TECHNICAL BULLETIN INDEX
Sorted by Bulletin Number
04/03/86

BULLETIN NO.: I:1

PRODUCT: 26-1140/1/2 Expansion Interface

Figure 1

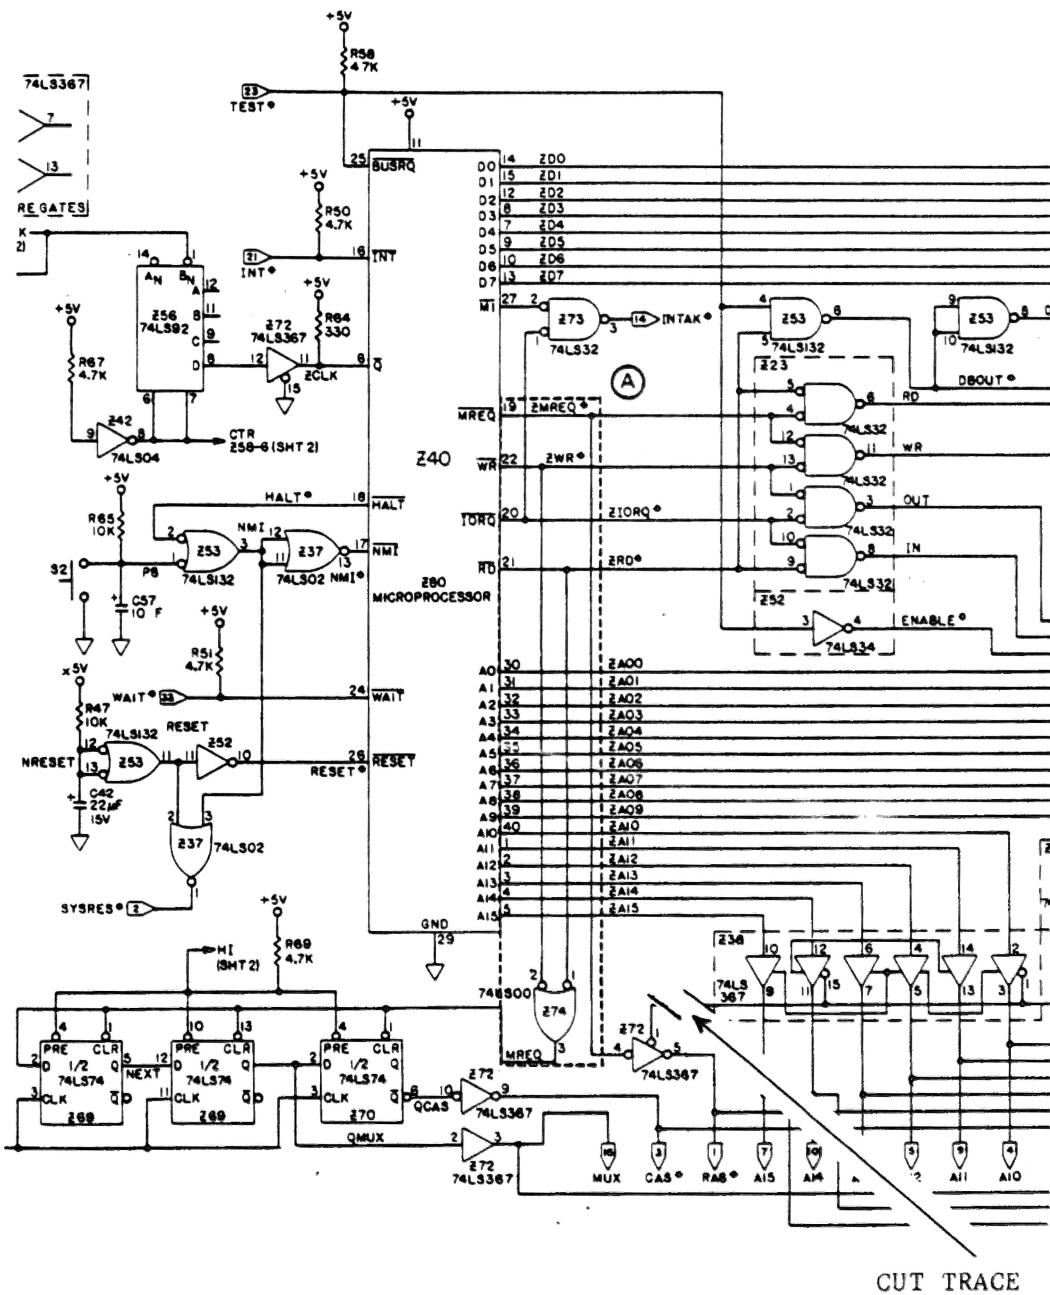
On the CPU, (refer to Fig. 1), the signal RAS* goes through non-inverting tri-state buffer Z72. When pin 1 of Z72 is low, RAS* will pass through. If pin 1 is high, the output of these buffers will have a high impedance state, be "turned off", and will not pass any signals.

Anytime the screen printer is printing, pin 1 of Z72 is high, and RAS* will not pass from pin 4 to pin 5 of Z72. With no expansion interface connected or with expansion interface and just the buffered cable connected, this line has the electrical appearance of being low when pin 1 is high. When the twisted pair modification is installed, this signal gets pulled high by the "pull-up" resistor on the expansion interface board. The same "pull-up" resistors are used with the buffered cable, but RAS* is buffered and, at the CPU, still is low at Z72 Pin 5.

So if the output of pin 1 of Z72 (Fig. 1) is pulled high, making RAS* high, pin 5 of Z73 (Fig. 2) will be high and no video addresses will be decoded. And when pin 1 of Z72 is low, all address buffers are enabled.

The correction is to cut the trace on the component-side of the CPU board going to pin 1 of Z72. Solder a wire from pin 1 of Z72 to pin 8 of Z72 (ground). This will leave pin 1 of Z72 always grounded or low.

Figure 2

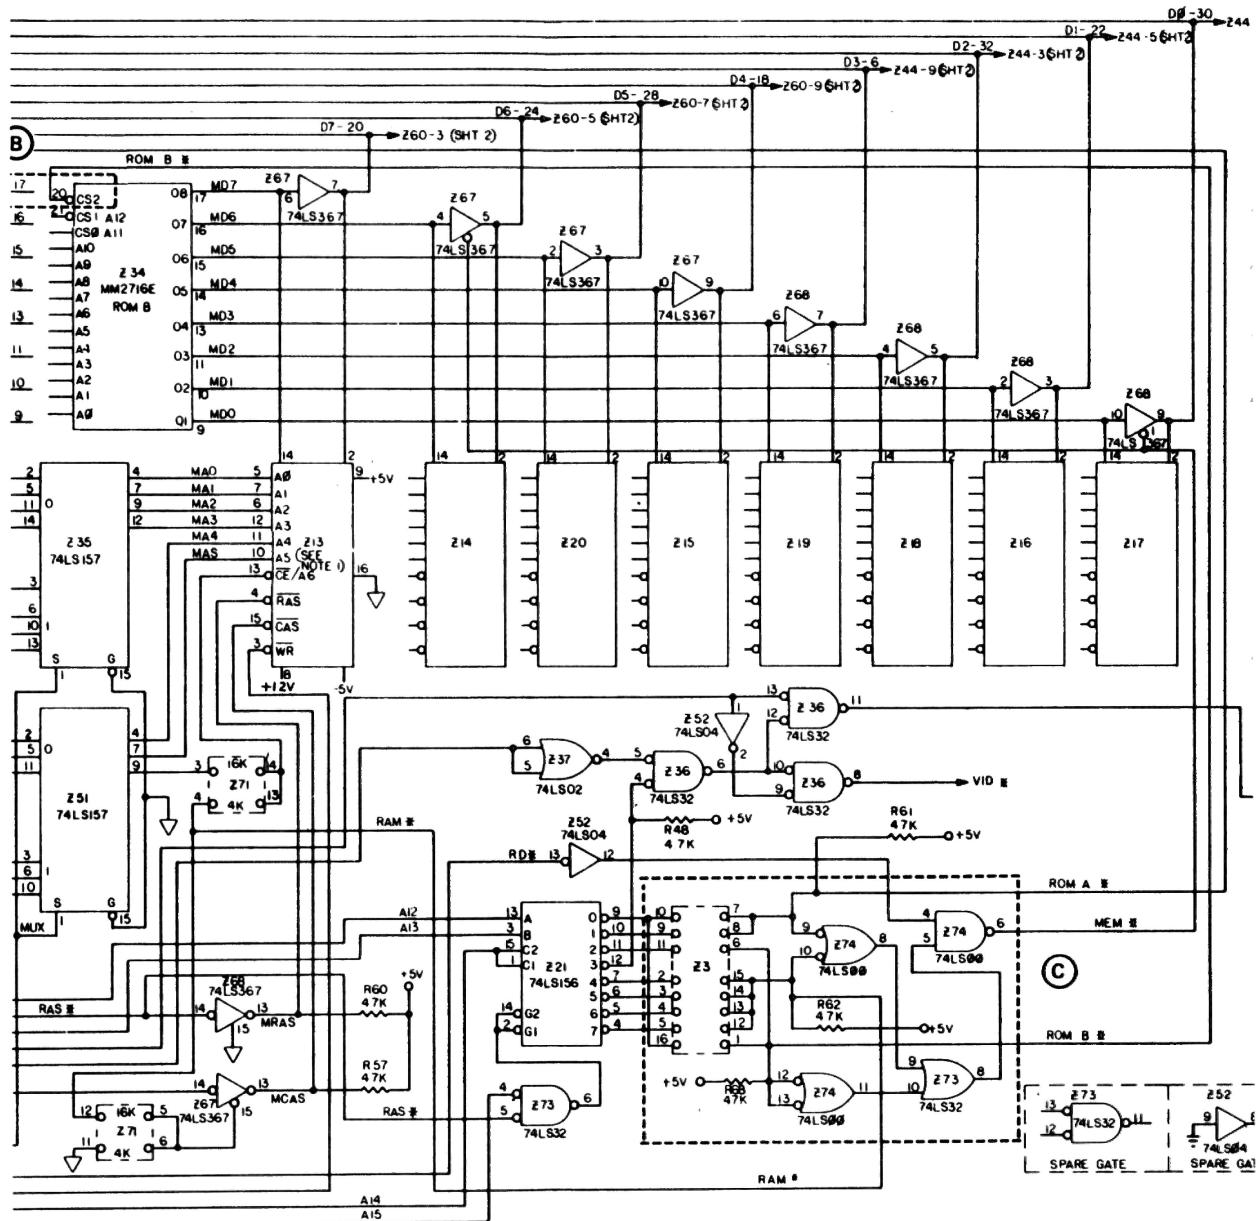
In the address decoding section, (refer to Fig. 2), AND gate Z73 has two inputs; A15 on pin 4, and RAS* on pin 5. The output of Z73 pin 6 is the enable for address decoder Z21. Z21 is enabled by a low at G1 and G2. In order for a low to come from pin 6 of Z73, pins 4 and 5 must both be low. If the decoder is not enabled, video memory will never be selected.

Figure 1

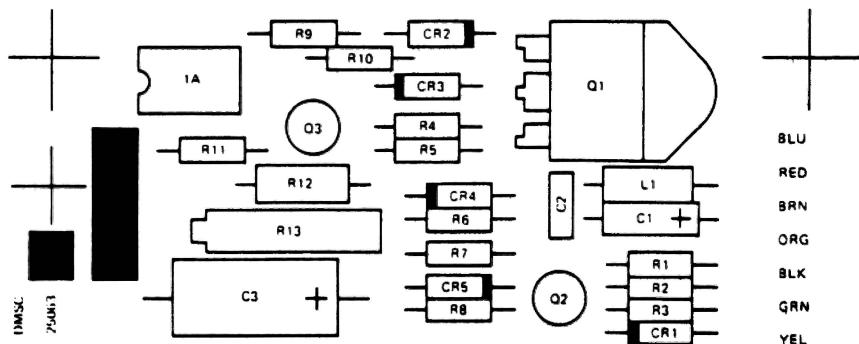
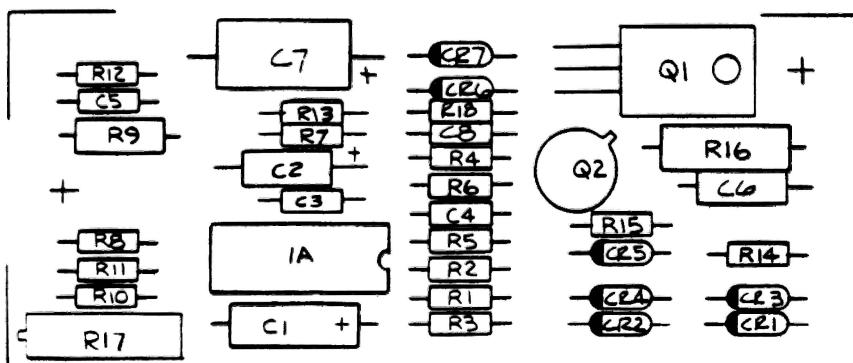
Some Disk Drive units manufactured during the period of 12/15/78 to 2/23/79 may exhibit spindle motor speed drift problems. The problem is caused by an unstable capacitor, C2, on the motor control PCB. There are two assembly versions for the motor control PCB, No. 25129 and No. 25063. Refer to figure 1 for PCB component location layout. The problem assembly (No. 25129), can be identified by a vertically mounted speed adjust potentiometer (R17), in the lower left corner.

If C2 on this PCB is a glass capacitor, then it should be replaced with a .015 ufd +-2% 50 volt mylar capacitor (Nat'l Parts# ACC-153GJMA 26-9999C).

FIGURE 1. COMPONENT SIDE OF P. C. BOARD

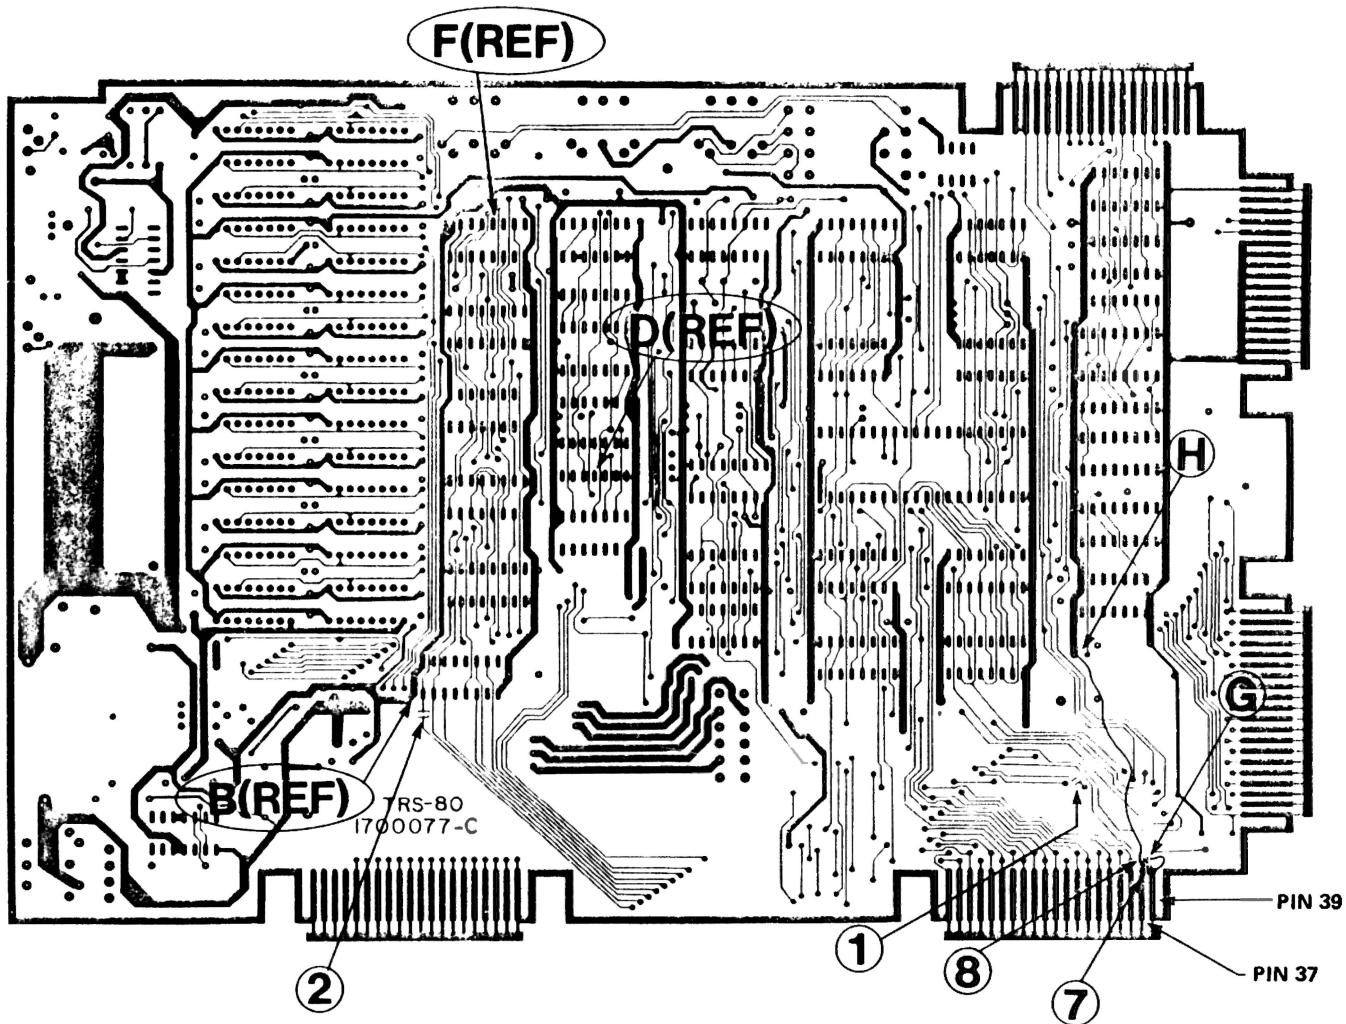
Procedures for Component Side of Board (see Figure 1)

1. Cut the MUX etch at points (1) and (2), above pin 23 of the Edge Connector and below pin 1 of Z17 respectively.
2. Cut the etch at point (7) between pins 37 and 39 of the Edge Connector.
3. Cut the etch at point (8) between pin 37 and point (G).
4. Connect pin 39 to point (G) with a 3/16" bare wire.
5. Connect pin 37 to point (H) with a 2 1/2" jumper wire.

FIGURE 2. COPPER SIDE OF P. C. BOARD

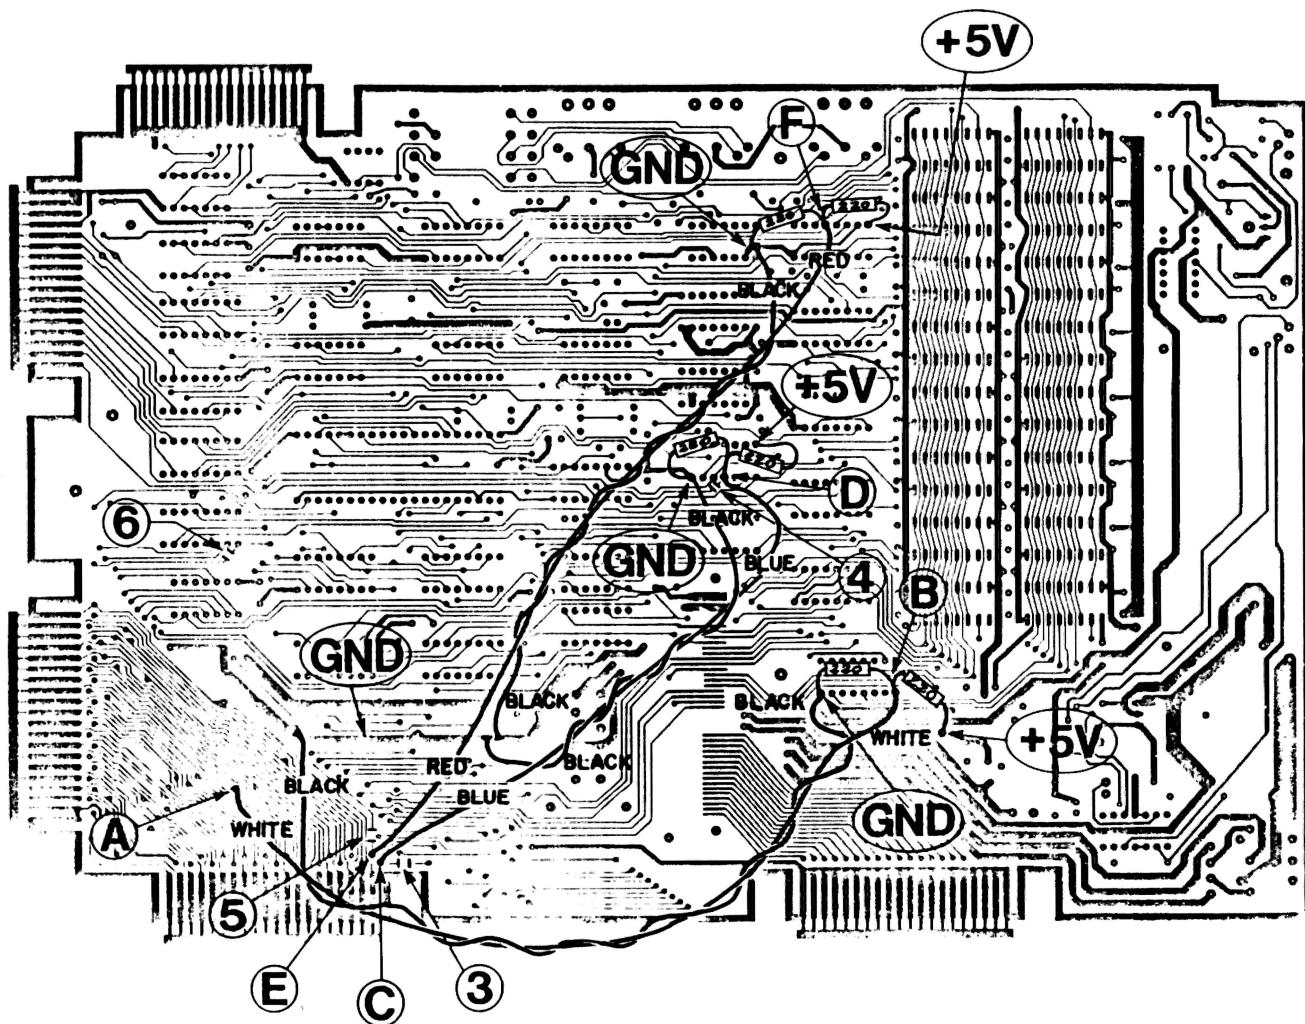
Procedures for Copper Side of Board (see Figure 2)

1. Cut the CAS etch at points (3) and (4), near pin 2 of the Edge Connector and below pin 4 of Z24.

2. Cut the RAS etch at points (5) and (6), above pin 2 of the Edge Connector and below pin 1 of Z43.
3. Prepare three pairs of 220 ohm resistors. Cut one lead of each of the six resistors to 1/4". Allow 1/8" and bend the lead into a right angle, then solder them together into pairs (see Detail A).

4. Solder the common lead of the resistor pairs to:

Point (B), pin 1 of Z17 (MUX)
Point (D), pin 4 of Z24 (CAS)
Point (F), pin 12 of Z22 (RAS)

Procedure for Expansion Interface board (see Figure 2)

1. If Buffer Cable modification above has just been installed proceed to step 3. If Buffer Cable was already in unit proceed to step 2.
2. Cut the White-Black, Blue-Black, and Red-Black twisted wires where they connect to the resistors pairs. Then cut the same wires at points (A), (C), (E), and the common ground. Discard these wires when finished.
3. Select the cable with the male DIN connector and connect the twisted wire pairs as described below.
4. Connect the Red-Black wire pair to:

FIGURE 3. LOGIC PRINTED CIRCUIT BOARD

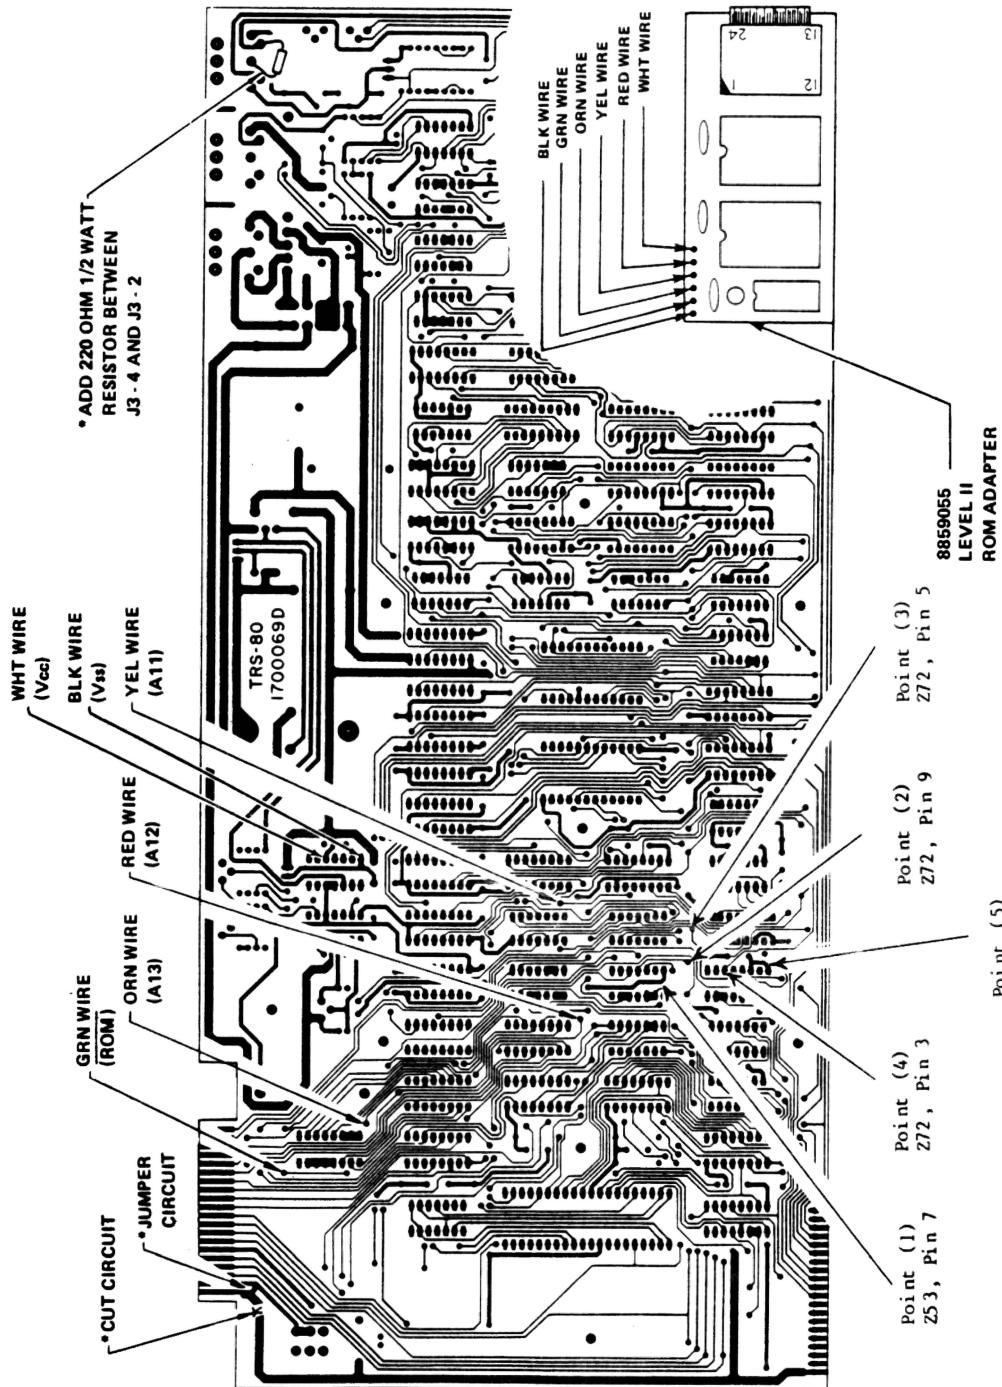
Procedure for CPU Board (see Figure 3)

1. Select the cable with the female DIN connector and connect the twisted wire pairs as described below.
2. Solder the common leads (Black) of twisted wire pairs Green-Black and White-Black to point (1).
3. Solder the Green wire (CAS) to point (2).
4. Solder the White wire (RAS) to point (3).
5. Solder the common wire (Black) of twisted wire pair Red/Black to point (5).
6. Solder the Red wire (MUX) to point (4).
7. Position the CPU board back into the lower case. Route the cable towards the CPU to EI edge connector. With a wire tie, tie the cable to the nearest case standoff, this will prevent the cable from being pulled loose at a later date.

Figure 1

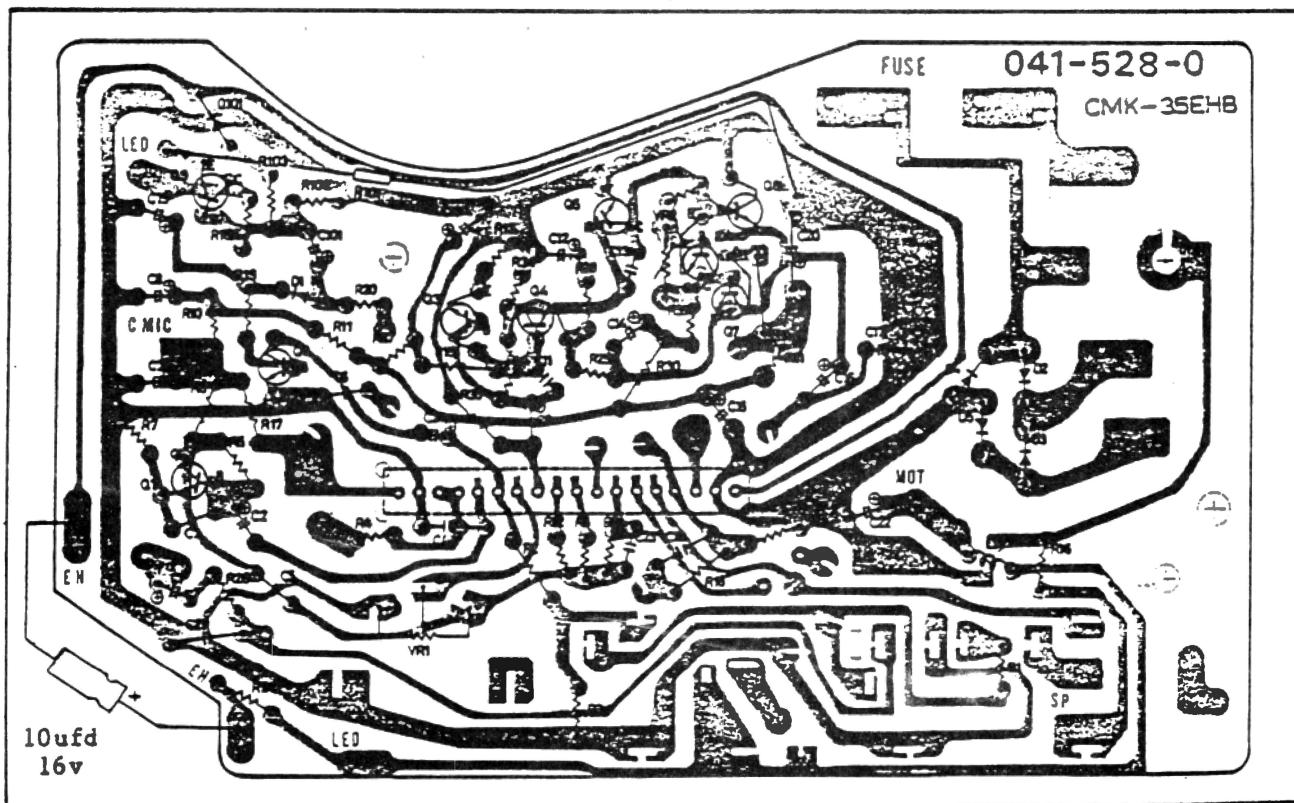
To correct the above problem install a 10ufd 16v capacitor (Nat'l Parts# CC-106QDAP 26-9999C) across the erase head terminals on the PCB, observing correct polarity.

Refer to figure 1 for PCB layout and capacitor location (lower left corner).

Figure 1. TRS-80 Microcomputer PCB, Bottom Side (Partial View).

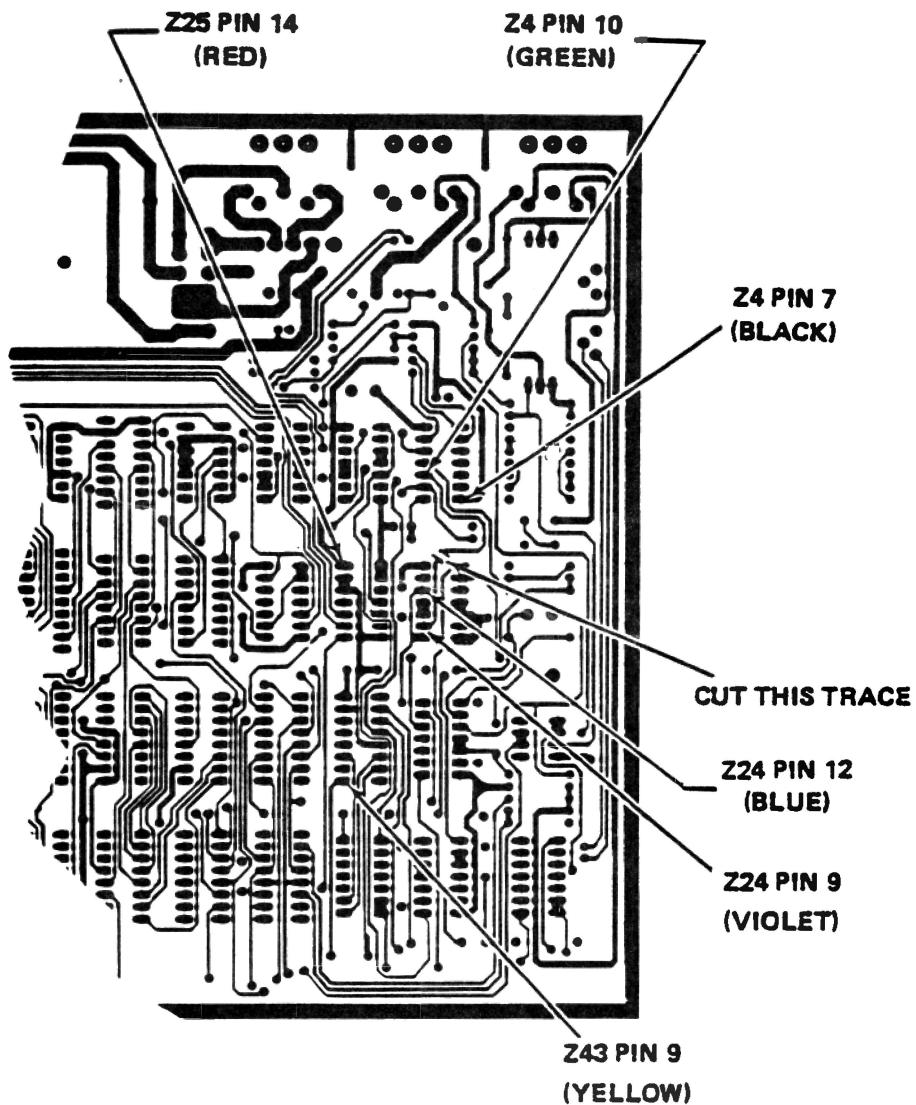
Refer to Figure 1 for the following procedures.

1. Place the modification PCB on the trace side in the upper right corner of the Model I Logic PCB.
2. Carefully cut the foil pattern between Z24, Pin 9 and Z4, Pin 10.
3. Connect the Red wire to Z25, Pin 14 (+5 volts).

4. Connect the Black wire to Z4, Pin 7 (ground).
5. Connect the Yellow wire to Z43, Pin 9.
6. Connect the Green wire to Z4, Pin 10.
7. Connect the Blue wire to Z24, Pin 12.
8. Connect the Violet wire to Z24, Pin 9.
9. Check all solder connections and then check operation with CSAVE and CLOAD.
